Customer Notification

VR7701TM

64-bit Microprocessor

Operating Precautions

No. 18

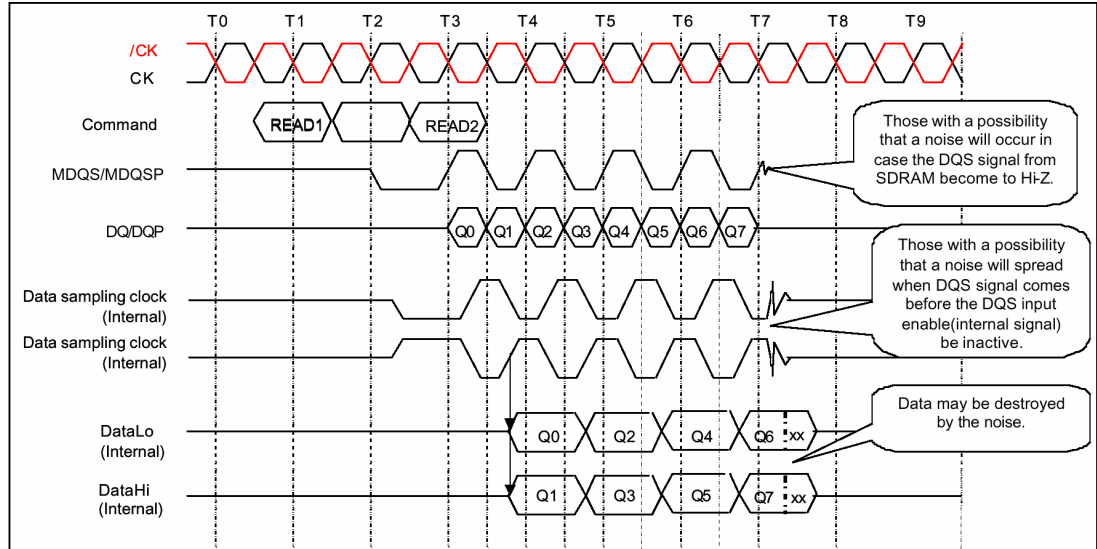
MMD(63:0), MMDP(7:0), MDQS(7:0) and MDQSP signal termination
(Specification change notice)Details

Noise on the MMD(63:0), MMDP(7:0), MDQS(7:0) and MDQSP pins may destroy memory read data as illustrated in below diagram.

To reduce the noise the following alternatives to standard termination of DDR-SDRAM data lines are recommended:
